ENGINEERING CHANGE NOTICE

1. ECN 186789

| | 5. Project Title/No./Work Order No. HIBBE/Vapor Extraction Characterization Unit | 6. Bldg./Sys./Fac. No. 216-Z Crib Sites | 7. Impact Level 2 ESQ |

Safety Assessment for the 200 West Area Expedited Response Action for Remediation of Carbon Tetrachloride

Figure 11. CCl_4 Vapor Extraction System Characterization Unit.

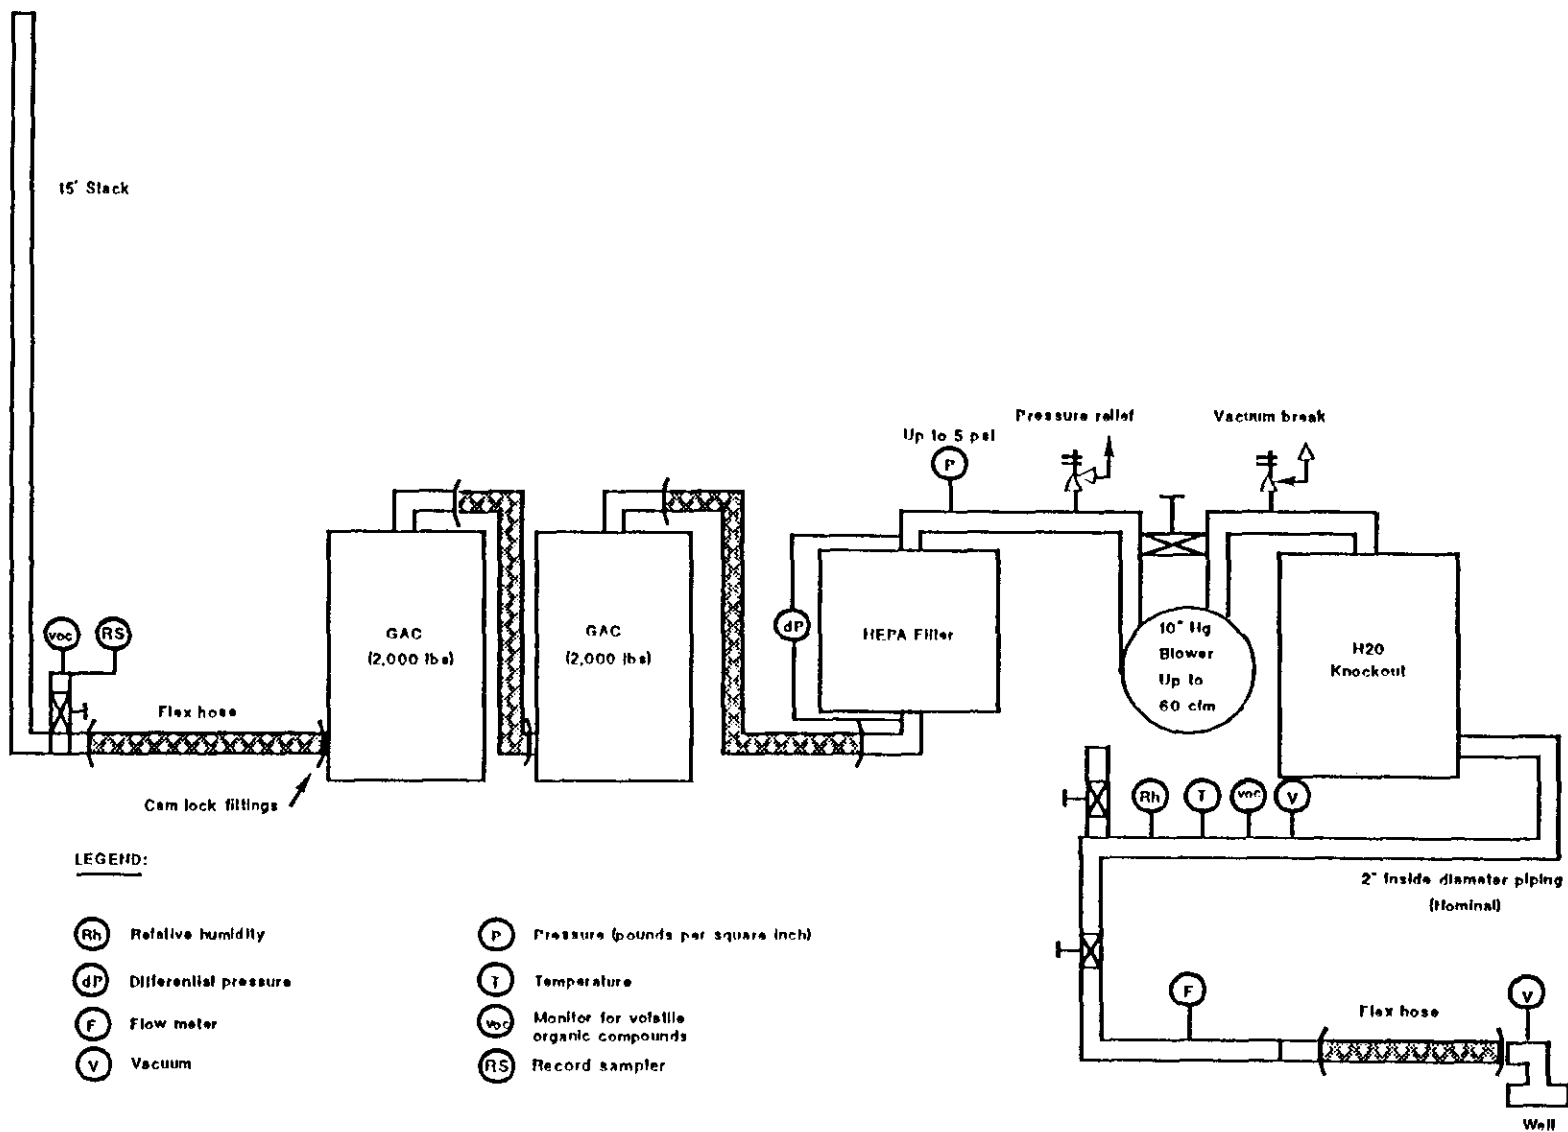
| (3) Revision | (4) Description of Change - Replace, Add, and Delete Pages | Authorized for Release | | |
|--------------|---|------------------------|---------------|------|
| 0-B | Replace pages 25 and 26; Figure 11 has been inserted. | | | |

A description of the specific components for the VES characterization unit is provided in Figure 11.
